## REQUEST FOR BOARD ACTION

### HENDERSON COUNTY PLANNING BOARD

**SUBJECT:** Combined Master and Phase I Development Plan for Rich Mountain Major Subdivision (2021-M09)

**Henderson County Planning Department Staff Report**  
**Combined Master and Phase 1 Development Plan**  
**Rich Mountain Major Residential Subdivision (2021-M09)**

Drawing Title:  
**EXISTING CONDITIONS & DEMO PLAN**

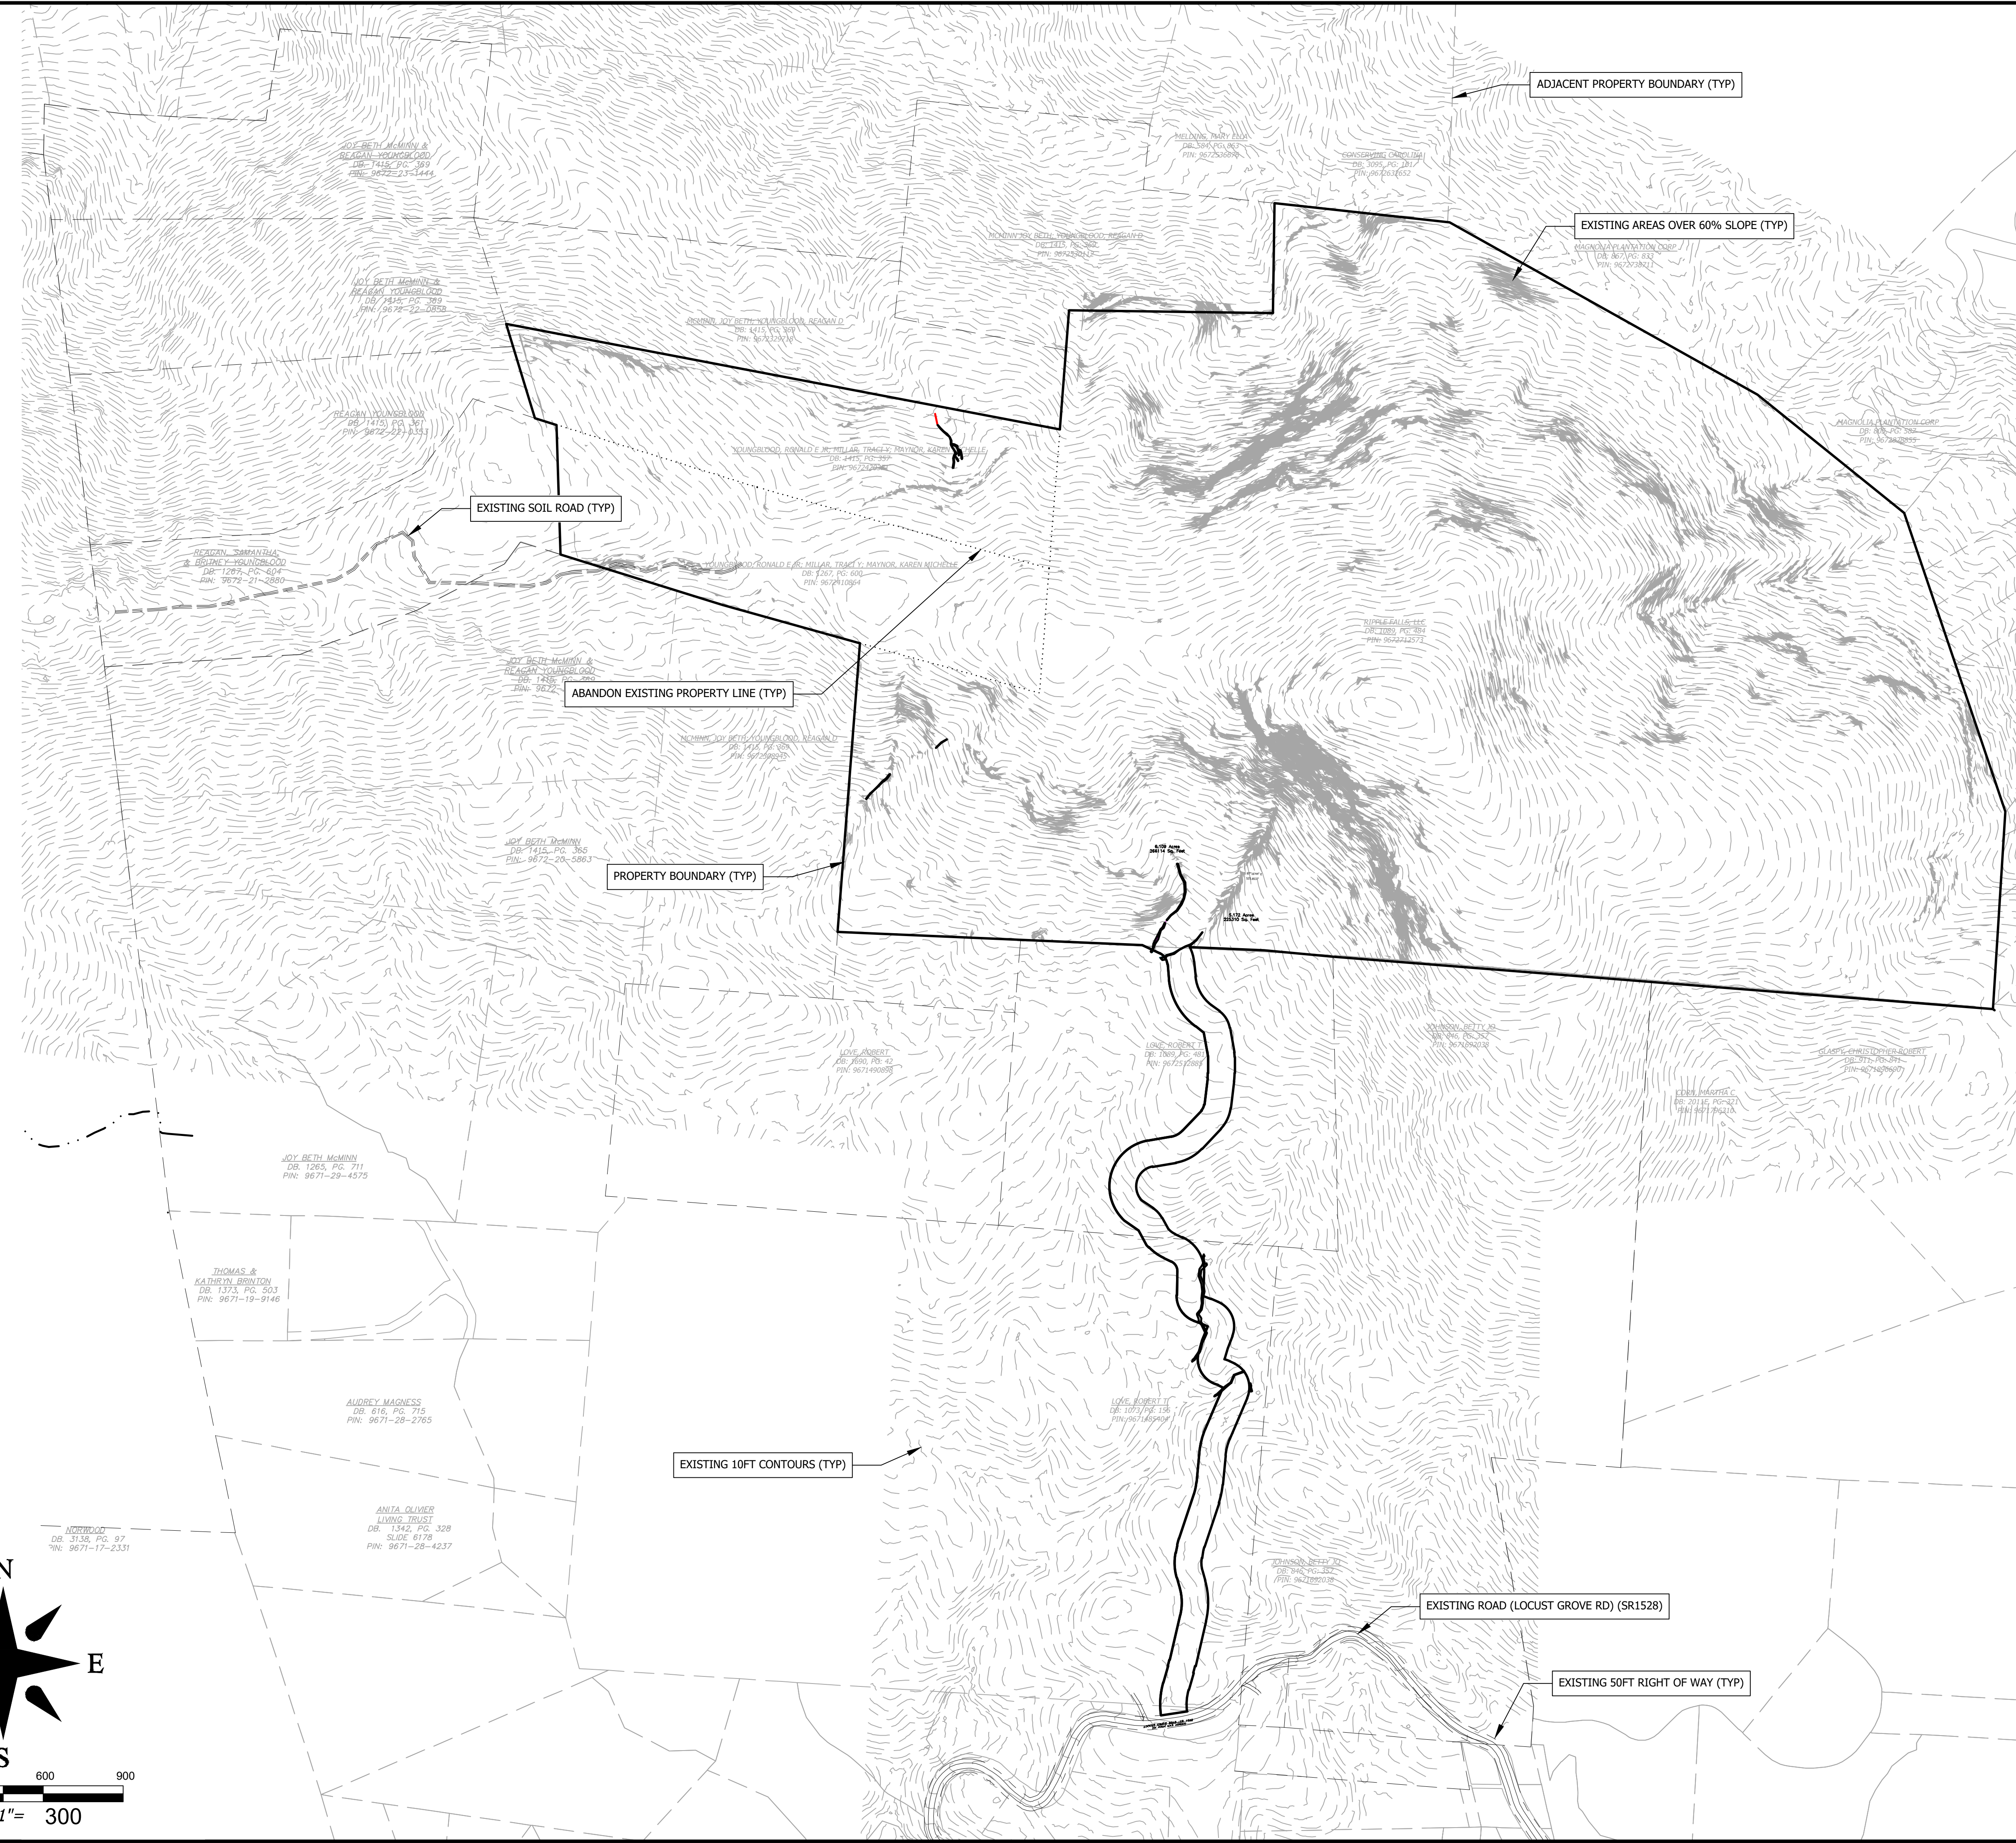
1. **Soil Erosion and Sedimentation Control Plan.** The Applicant shall submit written notice from the appropriate local agencies verifying that an Erosion and Sedimentation Control Plan has been received or a written notice from a professional land surveyor, engineer, landscape architect, architect, or professional planner certifying that no plan is required (LDC §42-95B).

2. **Water Quality.** The Applicant shall submit written notice from the appropriate local agencies verifying that a Stormwater Management Permit has been received (LDC §42-95E).

3. **Private Roads.** Private roads shall be constructed in accordance with the Private Subdivision Local Road standards stated in Chapter 42 (LDC§42-109). Additionally, subdivisions of 35 or more lots shall provide a minimum of two entrance roads. The second entrance road may be specifically waived by the approving authority where unique circumstances exist (LDC §42-95A (1)).

4. **Street Tree Requirements.** According to the street tree requirements of Chapter 42 (LDC §42-95H) the applicant must provide one tree per 50 linear feet of property abutting an internal road. Trees may be placed in groups with a minimum spacing of no less than 15 feet and a maximum spacing of no more than 65 feet. The trees may be placed within the right-of-way or within 20 feet of the edge of the right-of-way. The applicant may use existing trees in accordance with LDC §42-185 instead of planting new trees. These existing trees must also be located within the right-of-way or 20 feet off the edge of the right-of-way as required by LDC §42-185.

7. **Dead Ends, Cul-de-sacs and Turnarounds.** The Applicant proposes two (2) cul-de-sacs or turnarounds located at the ends of both local roads. All turnarounds must meet of the LDC §42-105 C(8).

10. **Perennial and Intermittent Surface Water Buffer.** All built-upon area shall be a minimum of 30 feet landward of all perennial and intermittent surface water, as defined in LDC §42-251.

13. **NCDOT Driveway Permit.** An NCDOT Driveway Permit is required for the proposed private, paved road, to access the site. Design should meet requirements of NCDOT.
